MCPC
MONONGALIA COUNTY
PLANNING COMMISSION

MEMORANDUM

Subject: Request for site plan approval of a Development of Significant Impact by Brandon Kupec in lieu of Little Mar, LLC for property legally described as Parcels 63, 64, 65, 66.1 of Map 8A in the Morgan Tax District

Meeting: April 9, 2025

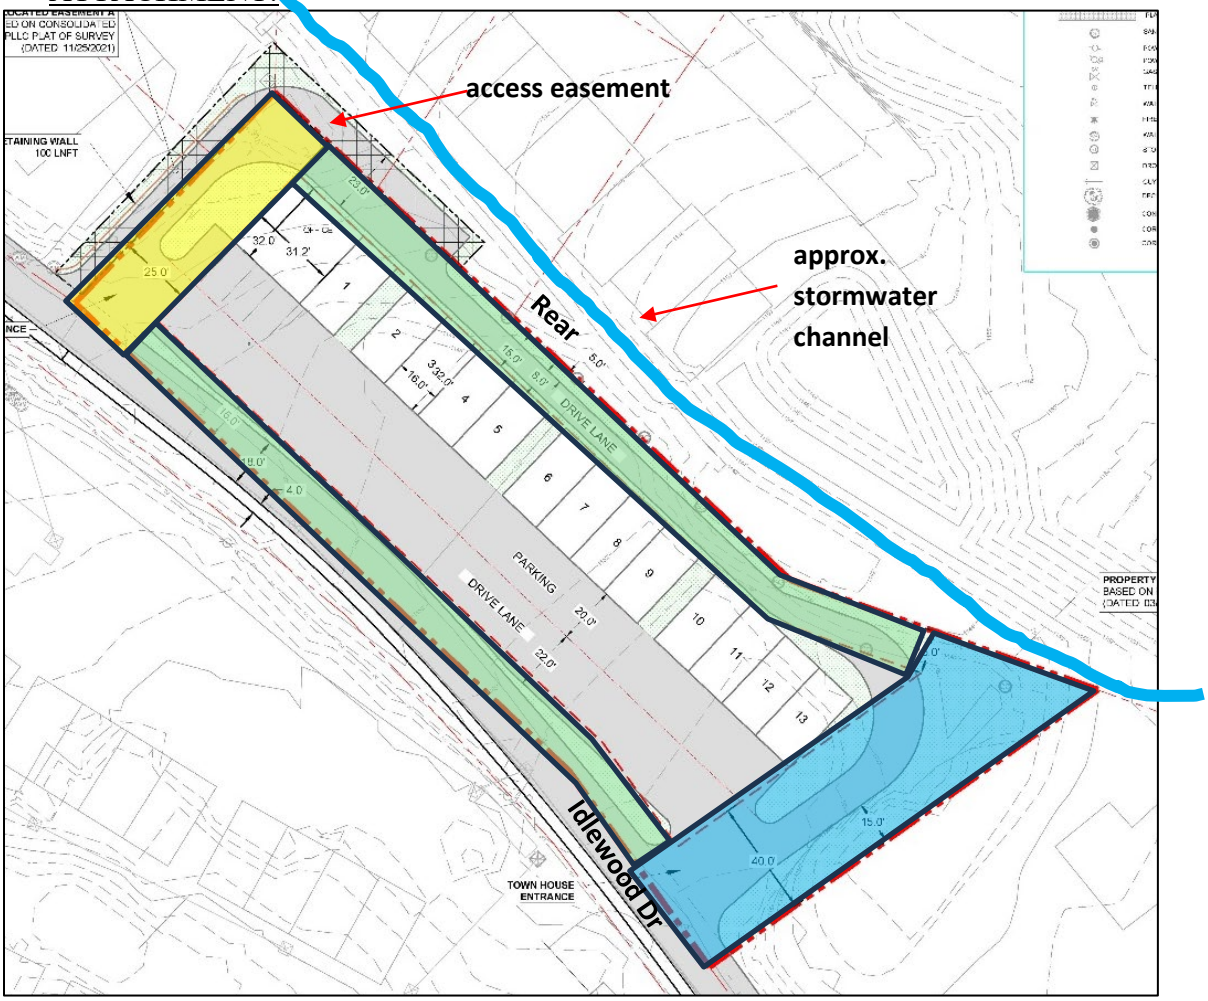
The site plan outlines what the applicant presumes to be the required front, rear, and side yard setbacks. The required 5-foot minimum drive aisle setback is also delineated as shown on the site plan (**see Exhibit A**).

Additionally, the property line goes out into the middle of the road, the buildable area is further reduced. The applicant has not measured this distance (as required by the Planning Office) **from the edge of pavement**.

There are portions of the development which will be up to 15 feet away from the rear property line (see Exhibit B). A variance application HAS NOT been applied for by the Applicant. Even if the applicant can successfully argue that the easement can be used as a street qualifying as frontage, then there would be 3 front setbacks, 1 rear setback and NO side setbacks according to the WRZO. The applicant would still need a variance.

B. The applicant has not applied for a variance to any of the required setbacks or even re-interpretation of the setbacks.
C. The width of the two-way drive aisle is undersized at 22 feet when it should be 24 feet minimum.

Exhibit C: ALTERNATE plan of the townhomes originally submitted October 2021, which shows 13 townhomes with DSI 001-2021.

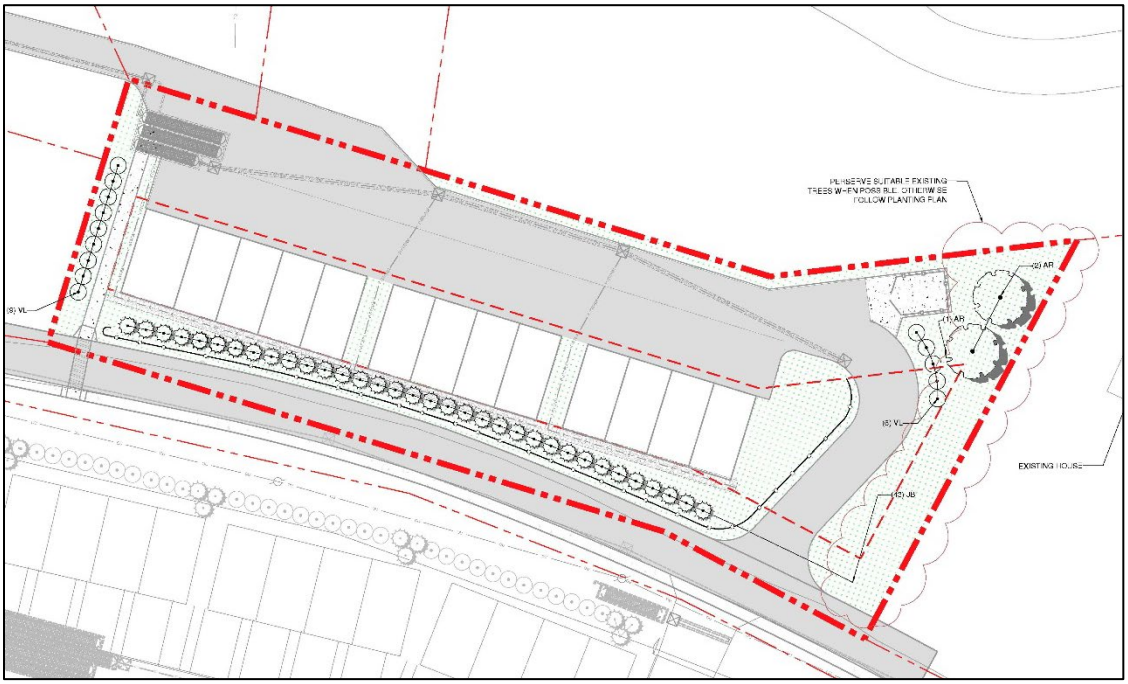
*Rather, a much less impactful layout that infringes far less on the setbacks – one with the buildings toward the front (**see Exhibit C?**).*

Exhibit E: Landscaping Plan

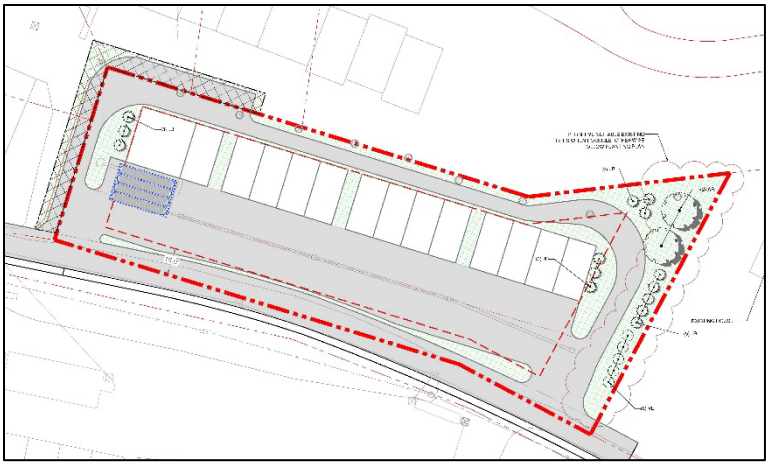
The landscaping plan addresses the single-family property to the east, which requires a buffer (**see Exhibit E**).

Exhibit H: Elevations and Floor Plans

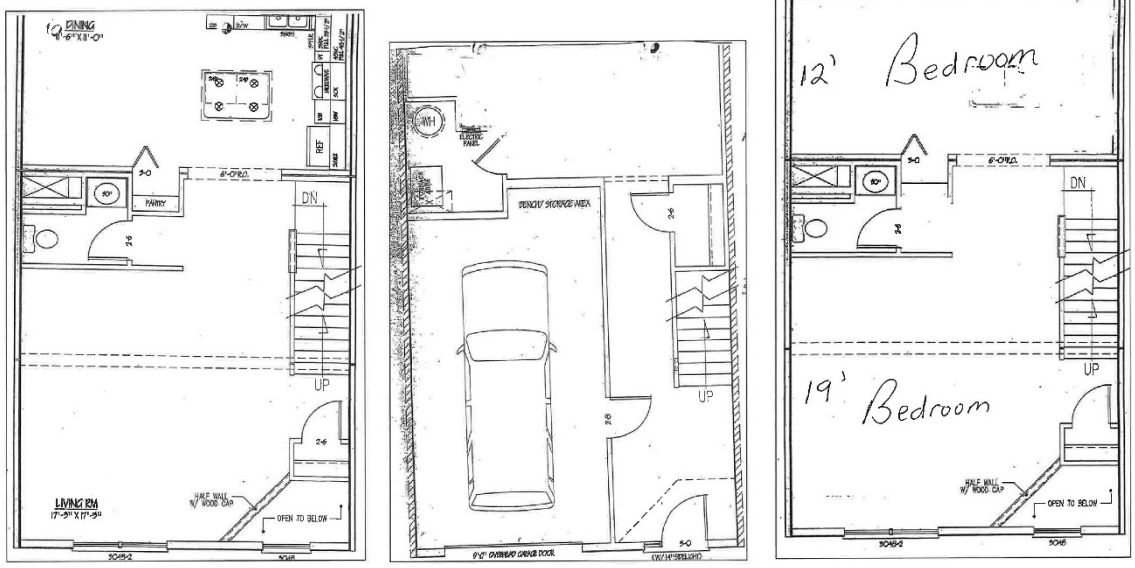
Based on the plans submitted (**See Exhibit H**), the proposed building will consist of 3 stories of habitable floor area not exceeding 36 feet.

The applicant has submitted floor plan outlining for both the two-bed units. Additionally, the units have been identified within the town house groupings (**see Exhibit A and H**).

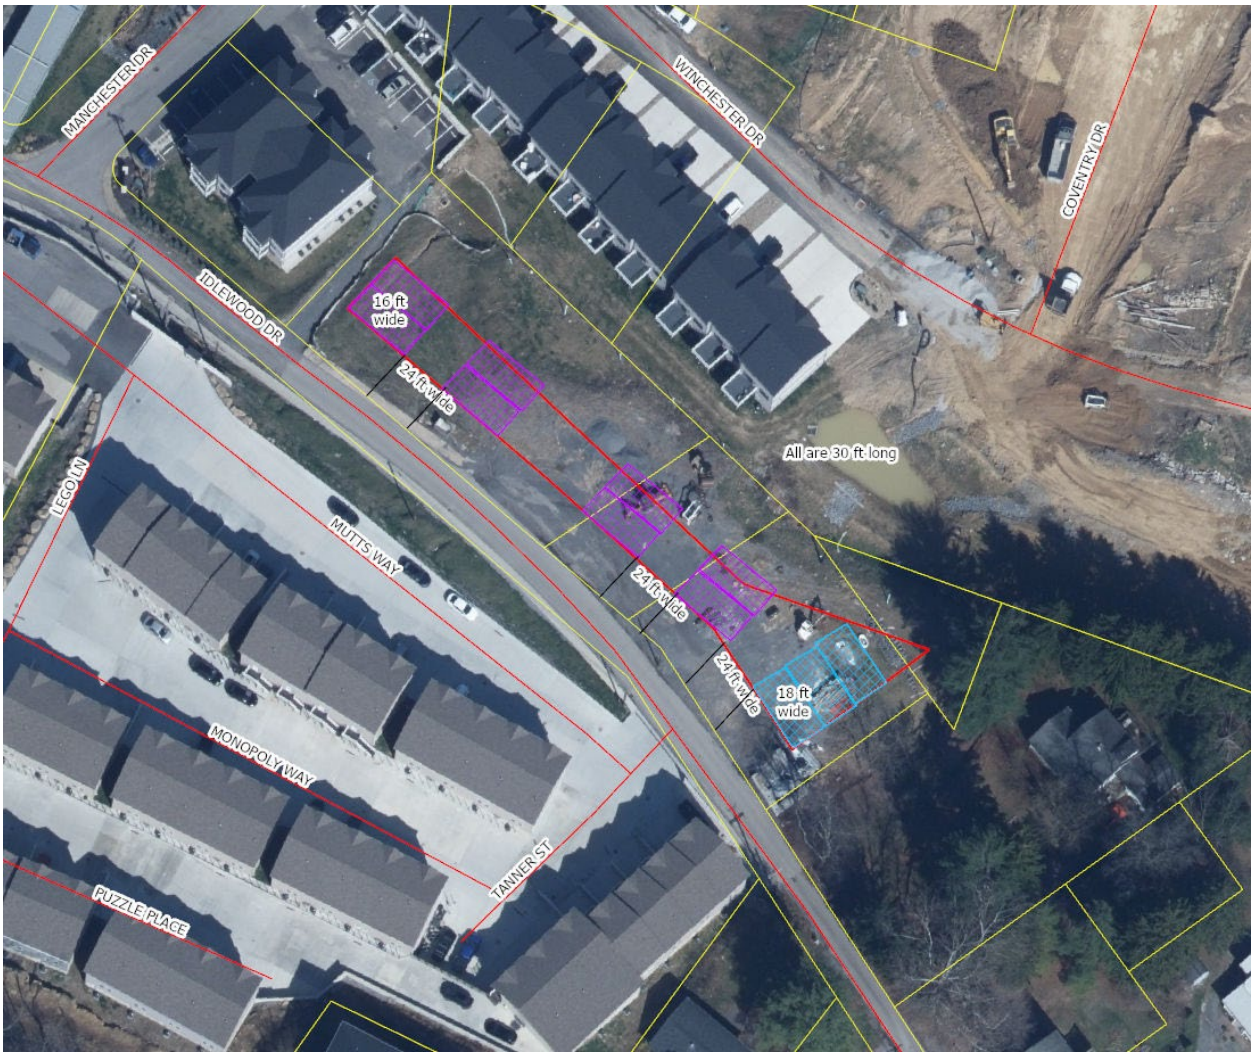
The problem is that this design encroached on the rear setback (actually was wholly within it) and that setback was needed to avoid stormwater issues. All wondered why Pavone did not simply propose what had been discussed. No understandable practical reason was provided other than an unsubstantiated cost (presumably removing the illegal fill was all of the sudden too expensive – though Pavone was the one who put it there).

What the applicant proposes (note the NW and NE access area is an easement owned by neighboring property):

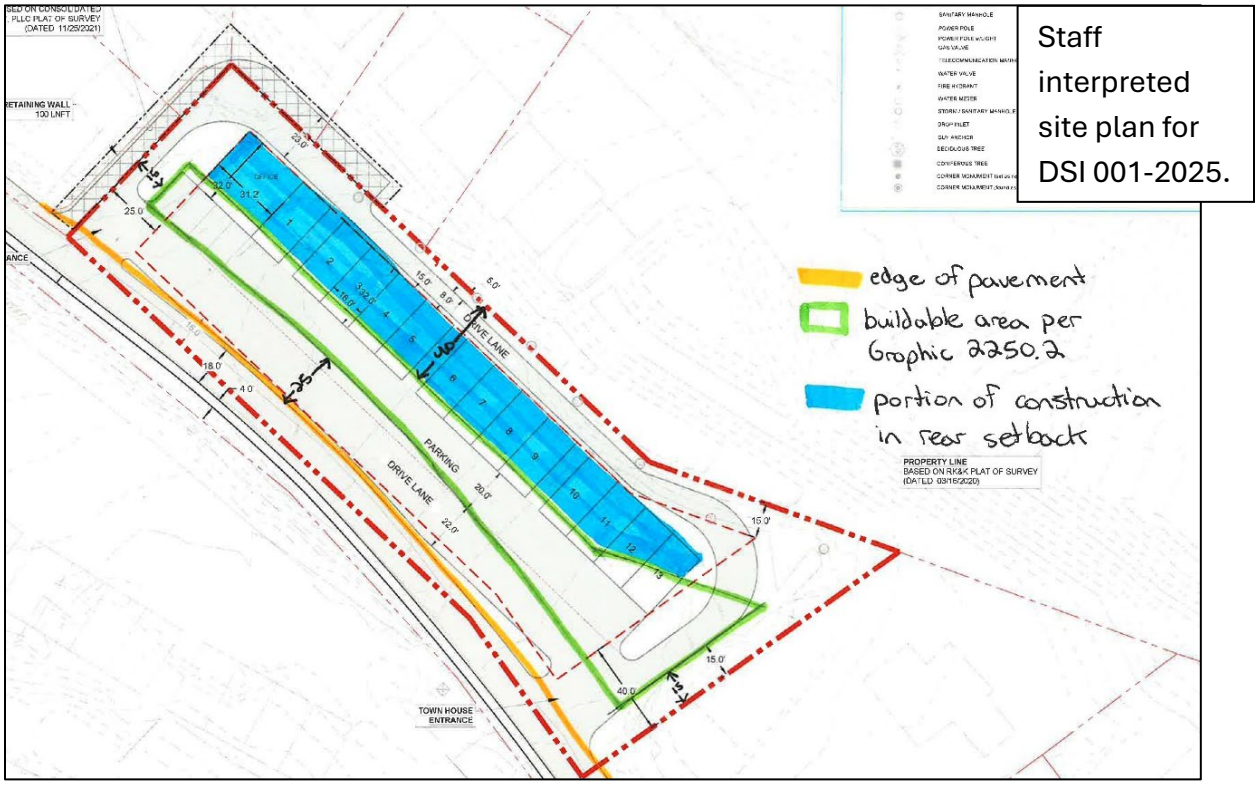
The site plan outlines what the applicant presumes to be the required front (yellow), rear (blue), and side (green) yard setbacks. The required 5-foot minimum drive-aisle setback (which is not an issue for the rear of the property) is also delineated as shown on the site plan. Based on 'saying' that the NW access easement can be considered THE 'frontage' street.

That easement is on land owned by the neighboring property, does not meet DOH street standards and was only provided historically to allow 'driveway access to the parking in the rear of the property for buildings close to Idlewood (see old photo pg 1). Even if we were to consider this the road, by 2250.39 that would mean that there would be 3 front yards of 25' setbacks.

Additionally, the property line goes out into the middle of the road, the buildable area is further reduced. The applicant has not measured this distance (as required by the Planning Office) from the edge of pavement.
